**BID: FM-50
CARPET REPLACEMENT AT COURTHOUSE**

**Addendum #1
dated 8-02-2018**

First Floor

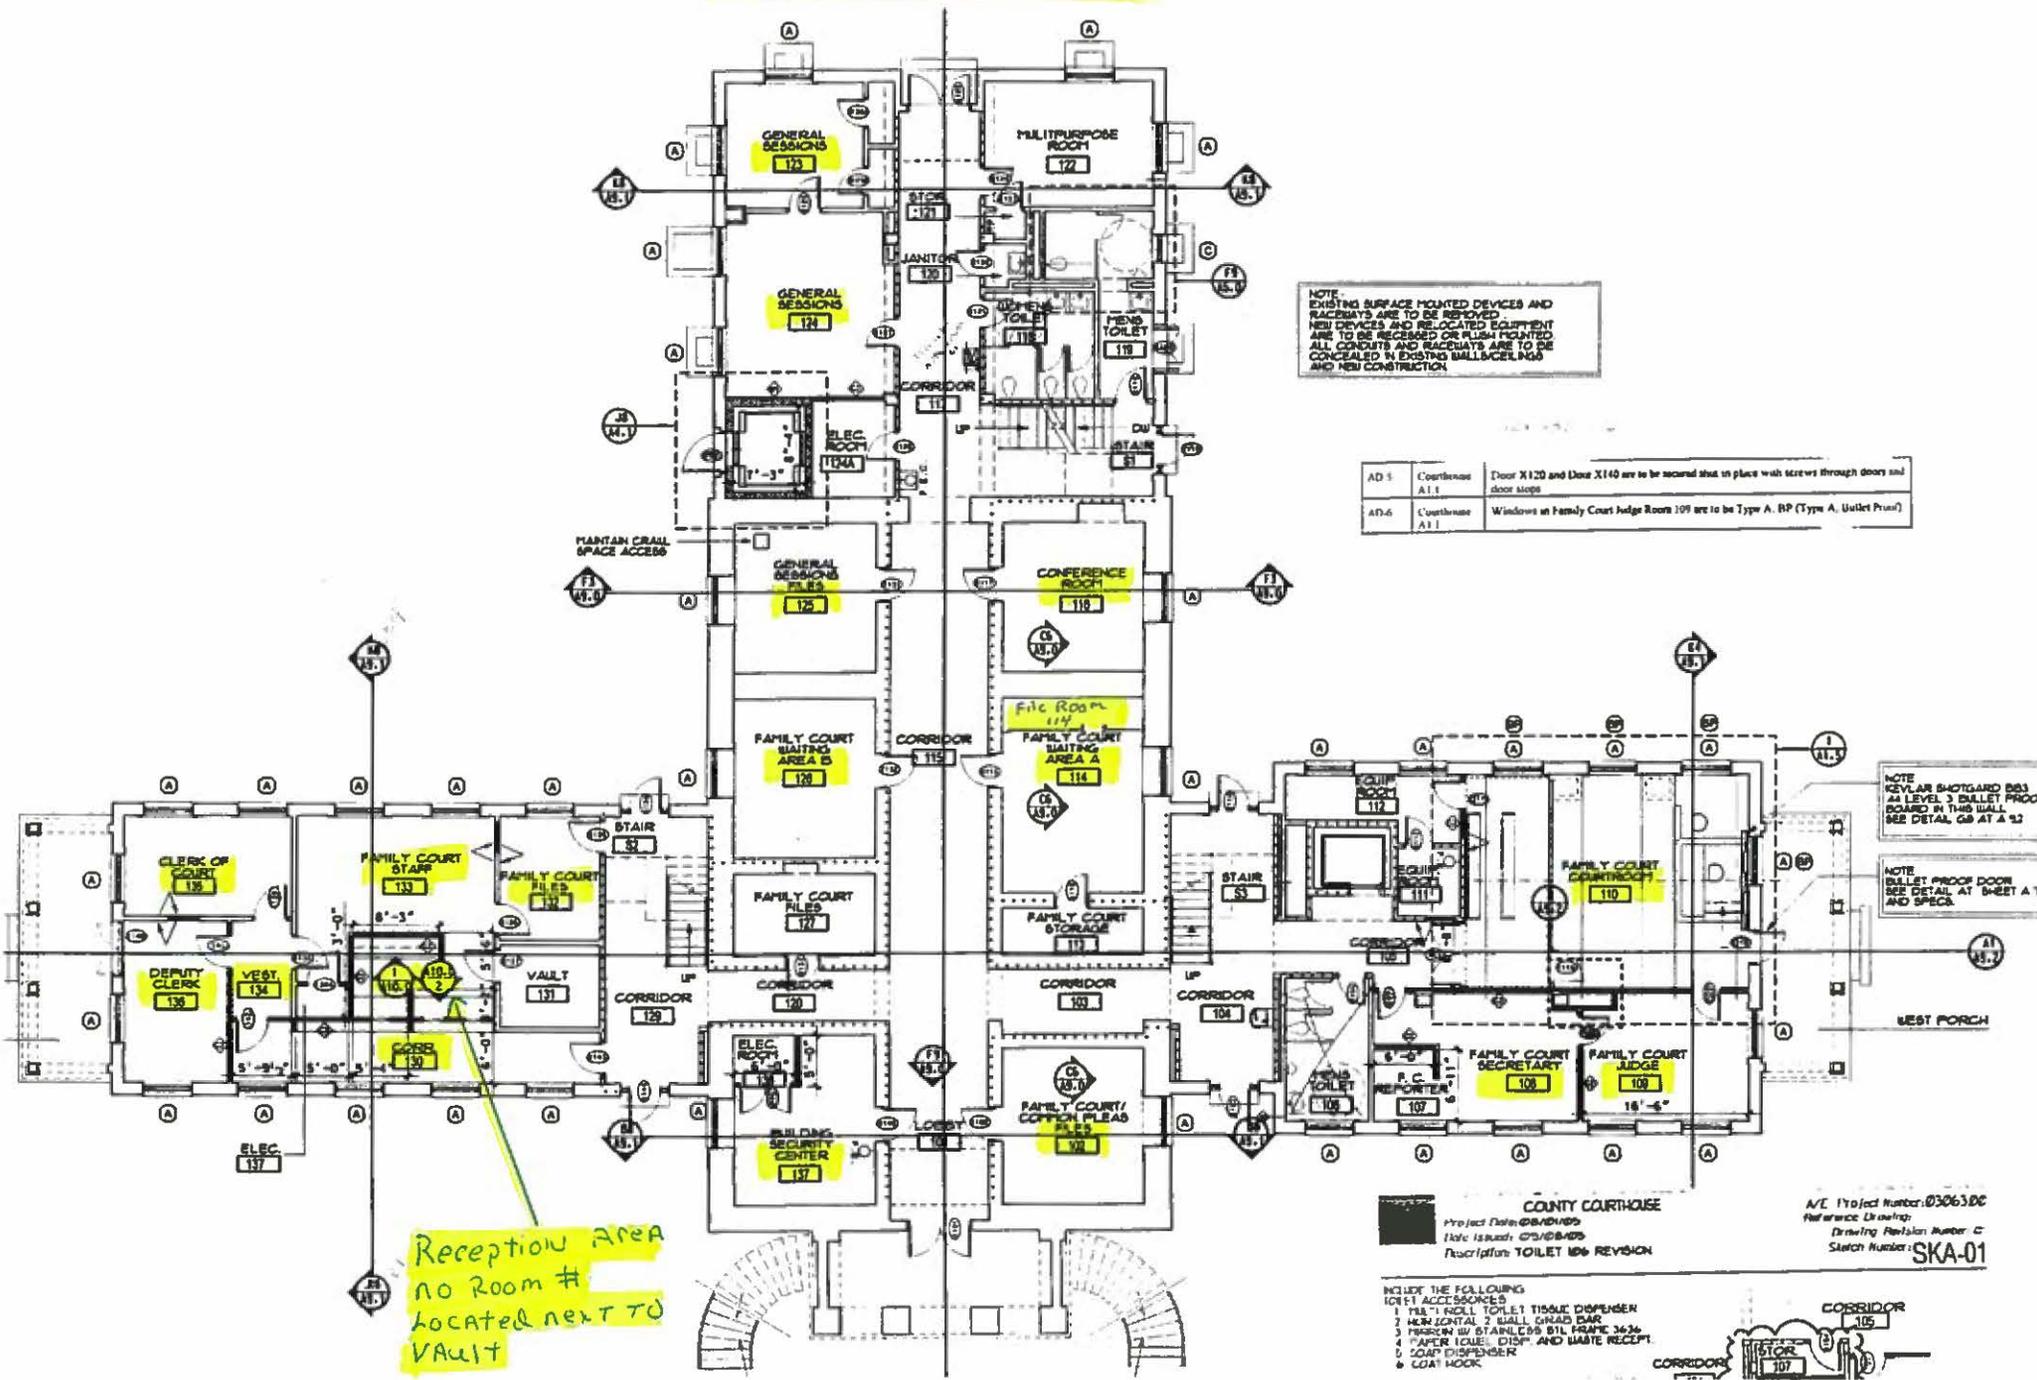
- Transition strips shall be full length. At no point should two transition strips be used to cover the edge of the carpet. (no splicing)
- Attached is the floor plan with the highlighted areas to be carpeted. All vendors are responsible for making sure their measurements correspond with the highlighted areas. The listed room names are of no value for the project. Contractor shall identify rooms by room number as noted on the floor plan.
The following rooms were noted as needing carpet:
First Floor: 102,106,109,110,114, file room 114,116,123,124,125,126,137,130,134,136,135, 133,132, reception area located next to vault.
Second Floor: 202,203,204,205,206,207,221,222,223,224,225,227,228,230,231.
